Access Compliance Report Public Rights-of-Way (Curb Ramps)

Main Street: CERRITOS_AVE		Cross Street: N/A		Location:	NE
ADA ID: RPAT220203145459	Ramp Type:Type 1 - Perpendicular	Initial Pass/Fail: Pass	Overall Compliance: No	Severity Score:	4

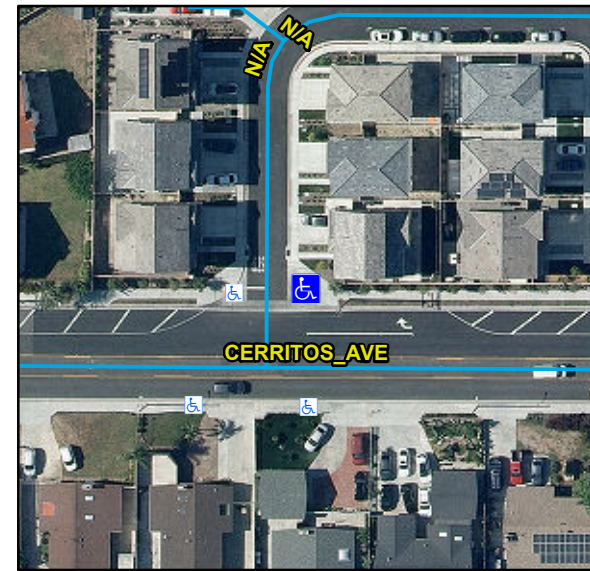
Possible Solutions:

Remove & Replace Landing.

OC Std/PROW:

R304.2.1, STD 1115
